明華大廈重建的
規劃大綱
PLANNING BRIEF FOR
REDEVELOPMENT OF MING WAH DAI HA

**Application for Permission under s.16A(2) of the Town Planning Ordinance
for Class B Amendments to the Approved Application (No. A/H9/69)**

**Extension of Time for Commencement of Approved Comprehensive Redevelopment of
Ming Wah Dai Ha (including Flats, Shop and Services, and Social Welfare Facilities)
at 1-25 A Kung Ngam Road, Hong Kong
(Application No. A/H9/69-2)**

Technical Comments of Director of Environmental Protection

Extracted from Noise Model

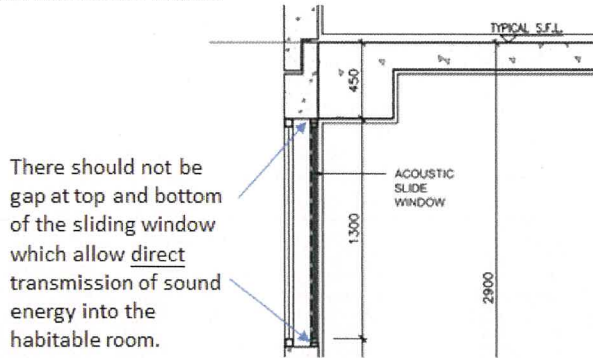
12. In our spot check, inconsistencies in revised EA report are found. The following are examples.
